Re: Proposed Water Supply Project for the Eastern and Midlands Region
in the counties of Clare, Limerick, Tipperary, Offaly, Kildare, and Dublin.

Ref No: PA92.323980¹ and CH92.323982²

Project: Wayleave No. IW/10001814/WL/388

Location: R407, Baltracey, Donadea, Co. Kildare

Figure 2: Existing visibility of the bend in the R407.

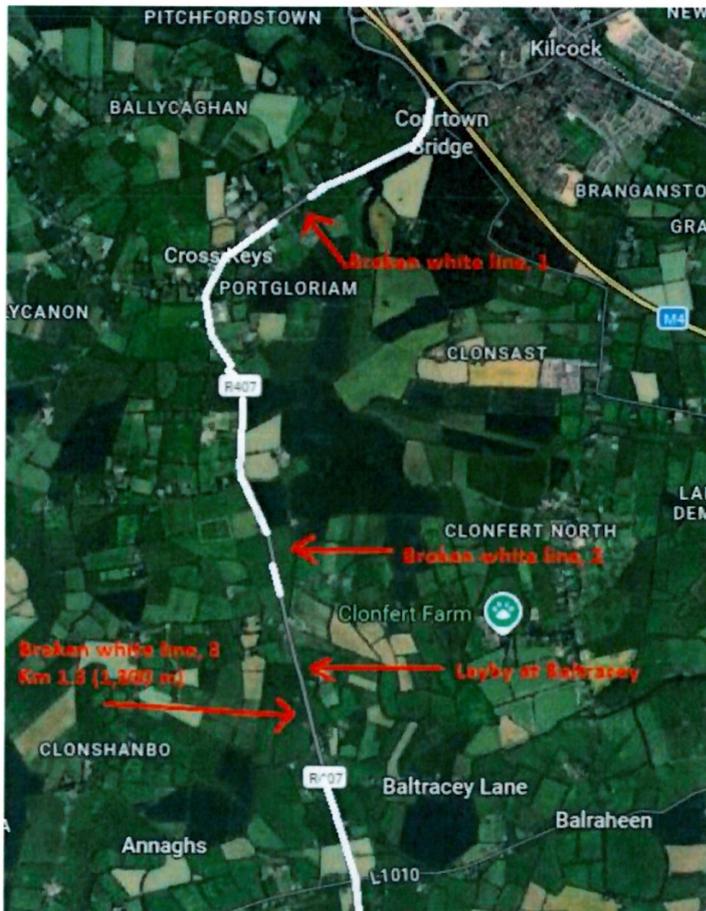
- A broken white centre line, where overtaking movements regularly occur;
- A history of serious traffic collisions locally, including fatal incidents; and
- Proximity to a bend approximately 250 metres to the north, which may reduce forward visibility for approaching vehicles.

In the context of these existing conditions, the introduction of a lay-by and additional access activity in close proximity to an established entrance would increase complexity and potential risk for local entrance and egress movements within the road environment.

Figure 4: Road markings in the vicinity of the proposed Permanent Wayleave

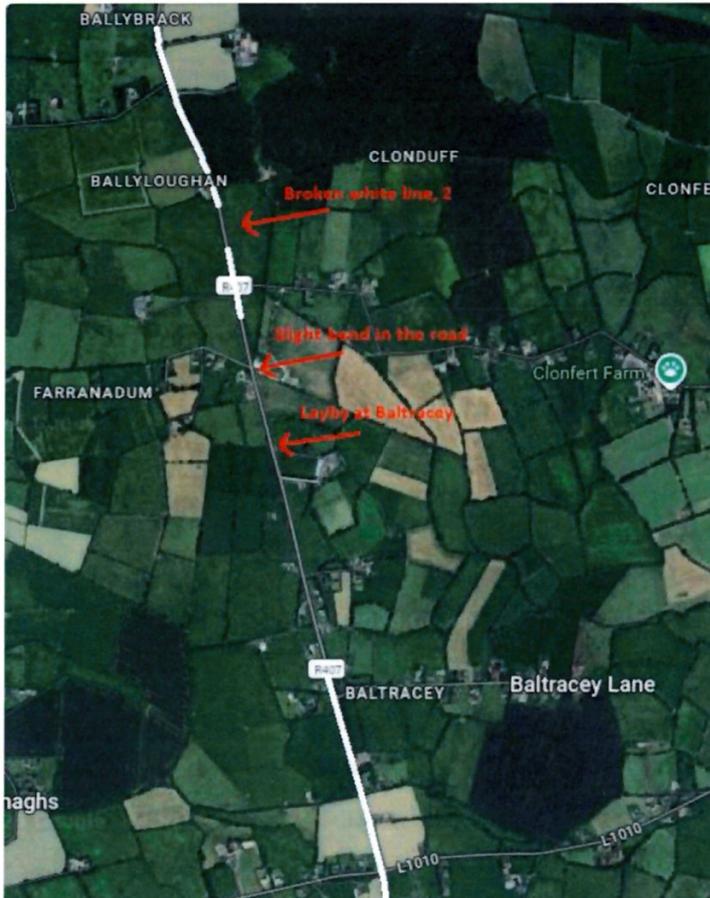
Figure 3 illustrates the road centreline markings along the R407 between Kilcock and Baltracree Cross. The route is predominantly marked with a continuous white centre line. Sections where the marking changes to a broken white line are identified below:

- No. 1: Approximately 100-metre section of broken white line at Portgloriam (The Mount).
- No. 2: Approximately 150-metre section of broken white line at Ballyloughan.
- No. 3: Approximately 1.3-kilometre section of broken white line extending from Ballyloughan to Baltracree Lane.

Figure 5: Multiple entrances into the farm adjacent to the proposed Permanent Compound (pipeline in a west–east direction).

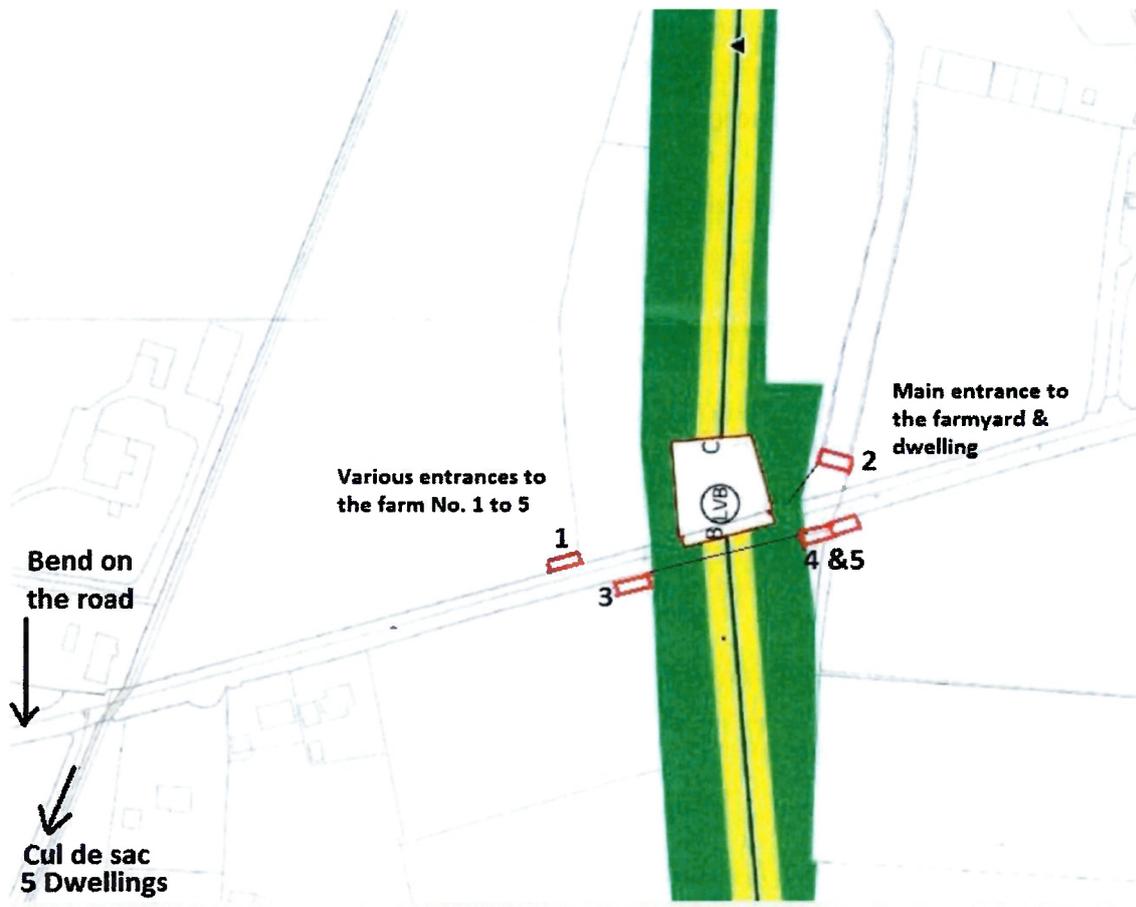
There are multiple farm entrances within approximately 100 metres of the proposed lay-by (see Figure 5).

The introduction of two additional access points (one temporary for five years and one permanent) in such close proximity would result in:

- Conflicting vehicle movements;
- Increased turning activity; and
- Reduced predictability for road users.

Figure 6: "2.9 Photographic Evidence of Sightline Impact"

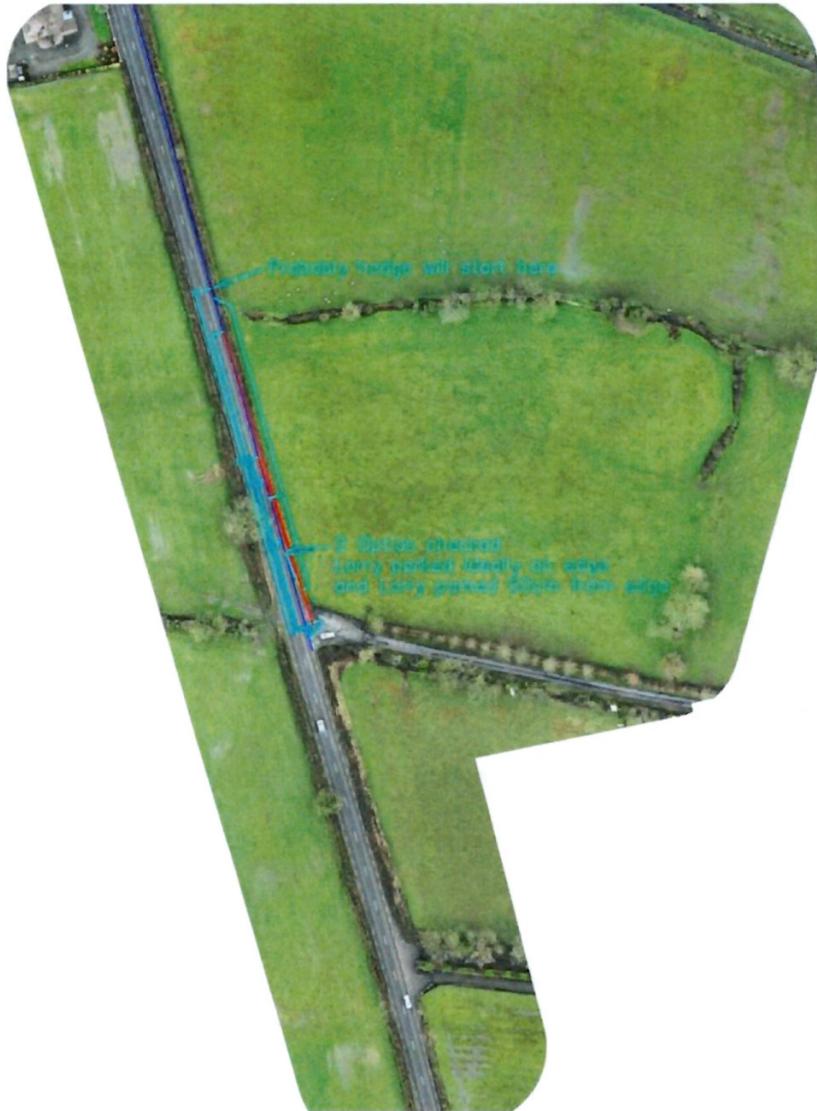
Attached as Figure 6 is an aerial image of the subject location showing:

- The position of my existing farmyard/dwelling entrance;
- The proposed location of the Permanent Wayleave/lay-by;
- The direction of sightlines required when exiting the entrance, particularly to the north (towards Kilcock); and
- The approximate extent of the required visibility splay.

The image demonstrates that the proposed lay-by is located within approximately 10–20 metres of the entrance, which is well within the required stopping sight distance of 120–160 metres for an 80 km/h road.

It also illustrates how parked vehicles within the lay-by, Uisce Éireann vehicles attending the site, and boundary treatments such as fencing or hedging have the potential to obstruct visibility within the critical sightline required to safely exit the entrance.

Figure 7: Proposed underpass drawing (2023).

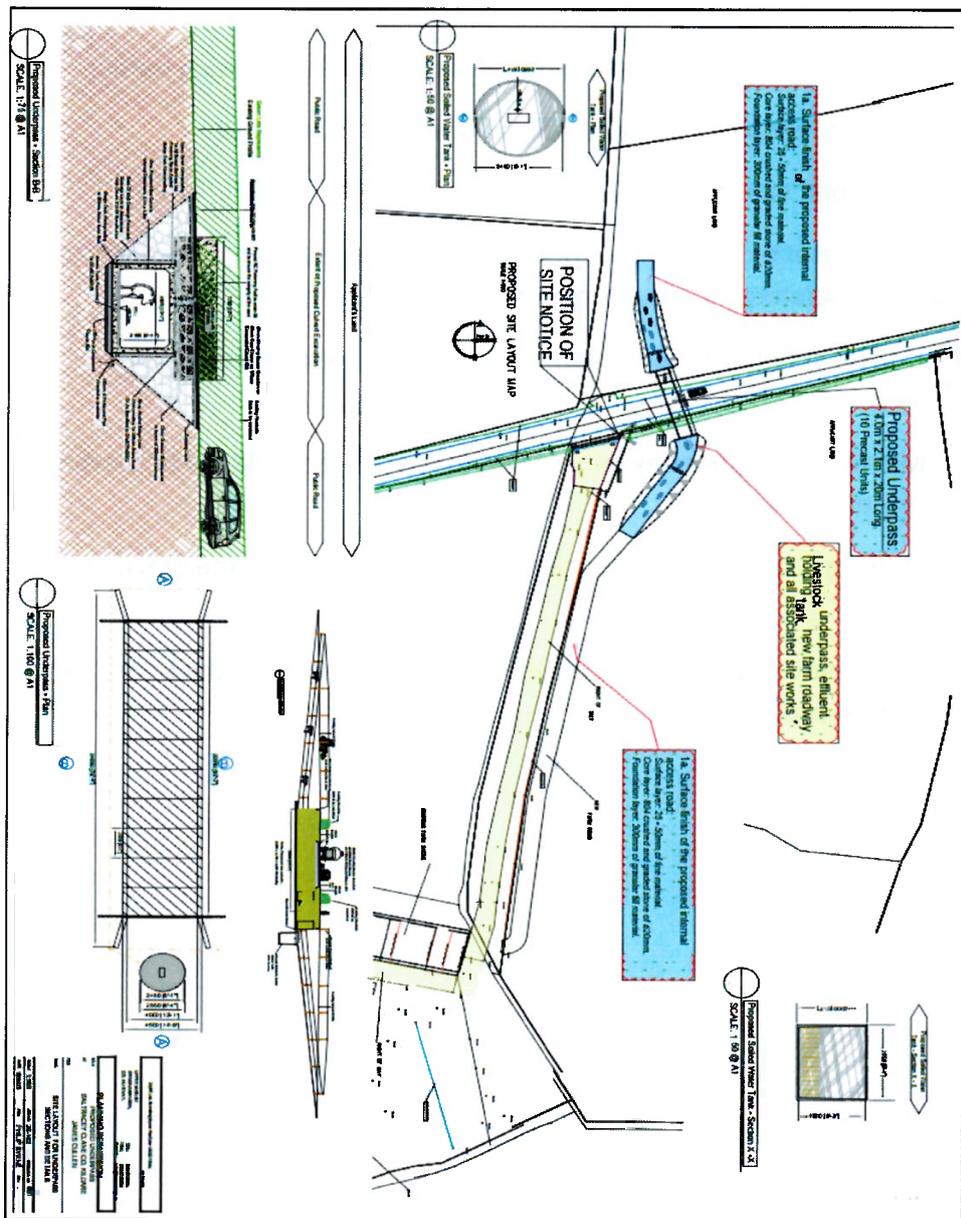
However, the current proposal by Uisce Éireann, in particular the location of the Permanent Wayleave, lay-by, and associated infrastructure, has the potential to:

- Sterilise or severely constrain the location where such an underpass could be constructed;
- Introduce physical and engineering constraints that would complicate or prevent future development; and
- Conflict with the alignment and access requirements identified in the previously prepared design.

It is essential that any development at this location does not compromise the ability to deliver this future safety improvement.

Figure 8: Alternative Location – Approximately 2 km to the East.

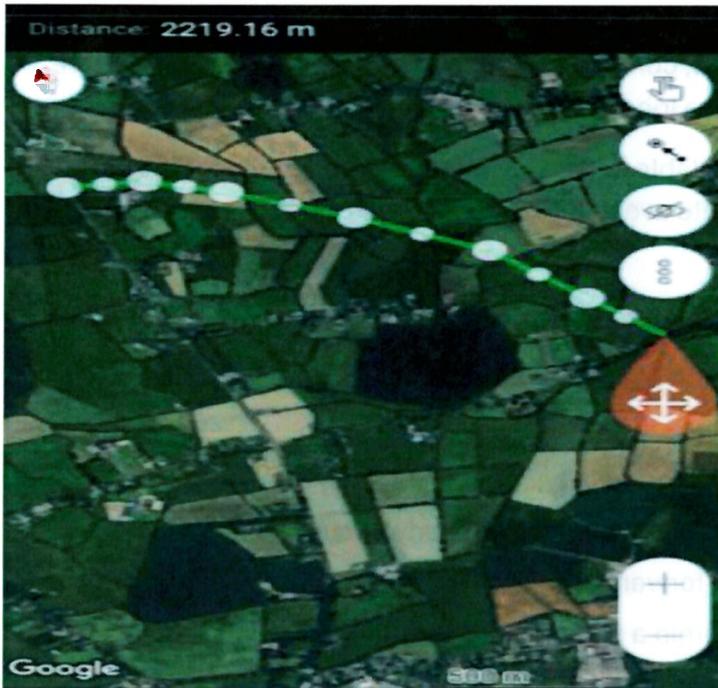
An alternative location exists (Figure 8) approximately 2 kilometres to the east of the subject site on a local road network with:

- A lower speed limit;
- Significantly reduced traffic volumes;
- Improved opportunities to achieve and maintain adequate sightlines;
- Reduced levels of overtaking and driver conflict; and
- Less interaction with agricultural operations and residential access points.
